Planning Officer's Report - LDCA NOVEMBER 2019

APPLICATION 2020/77 – Proposed Construction of a Prefabricated Steel

Building for Drainage Depot including minor Earthworks for access and construction of the base slab and also a vehicle

APPLICANT Connect St Helena Ltd

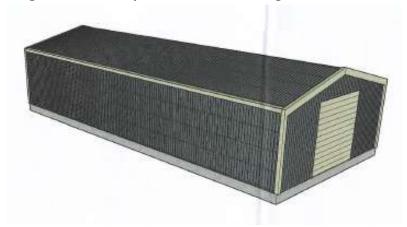
- drawing CSH RH 001: the roof ridge-line is shown higher than the adjacent containers but on the AMD elevational drawing it is shown lower than the containers;

- drawing CSH RH 001: plan and section shows considerable disparity in the relationship between the existing containers and the proposed building, the section shows an earth bank in front of the containers that is propose to be removed, however it appears to be a designed landscape bank to reduce the visual intrusion from distant views;

- similar new bank would be an advantage to do the same for the new building. However the section does not extend v across the full new hardstanding area and so that is not clear and this areas needs additional detail and landscaping;

The slight disparities in the drawing is not a big concern, the important issues that the dimension of the building on the main drawing are correct to determine the height. The 3D impression is assist in the assessment of the impact and details can be slightly distorted, particularly with the imaging of the land terrains. The development could benefit from additional landscaping and this can dealt with as a condition to reduce the visual impact on the landscape.
